ORIGINATION FORM

Proposed Revisions to a Standard Plans Index (Please provide all information — Incomplete forms will be returned)

Index Number: 455-020

Index Title: 20" Square Prestressed Concrete Pile

LAST REVISION 01/01/12	DESCRIPTION:	FDOT FY 2020-21 STANDARD PLANS	20" SQUARE PRESTRESSED CONCRETE PILE	INDEX 455-020	SHEET 1 of 1
------------------------------	--------------	--------------------------------------	--------------------------------------	------------------	-----------------

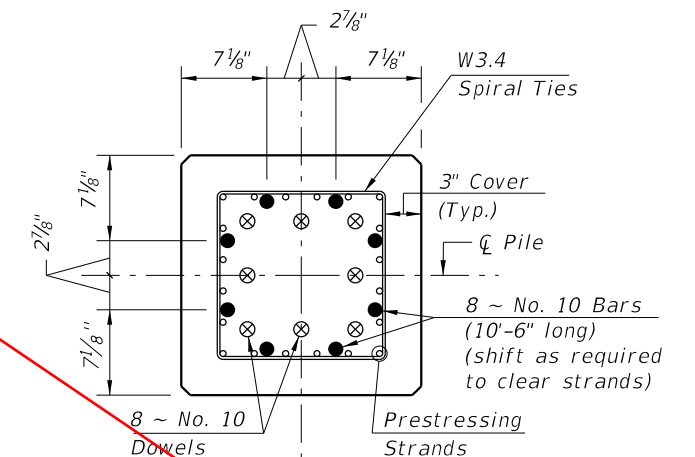
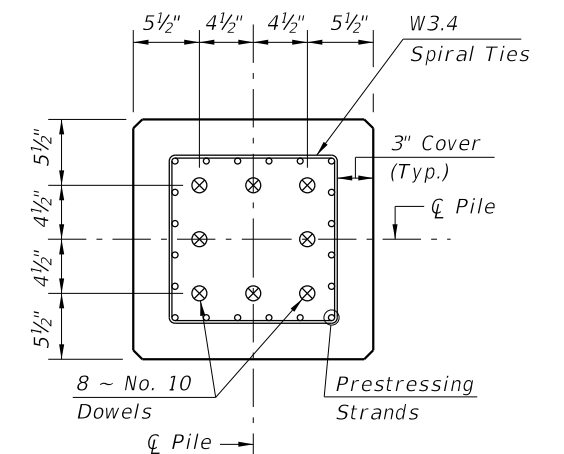
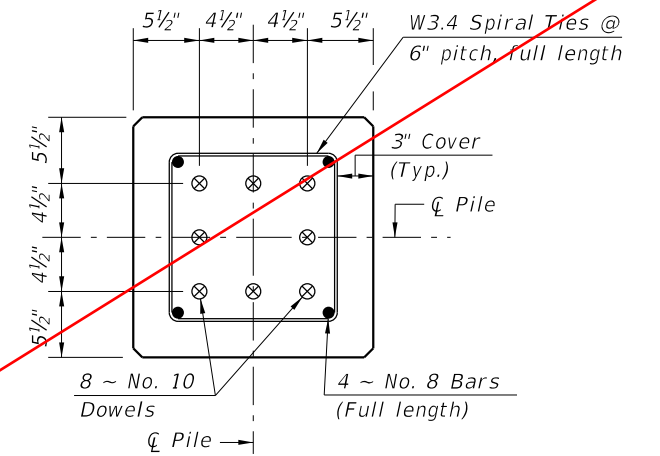
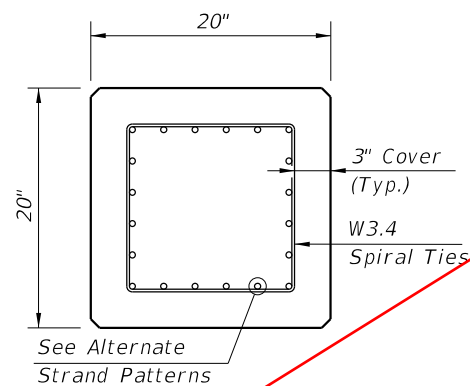
Delete Index (Sheet 1 of 1)

Uncommon size, not used; therefore the forms are not readily available should it be called for. Costs more than a 24" pile.

DELETE ENTIRE INDEX** See Note 4 on Index 455-002
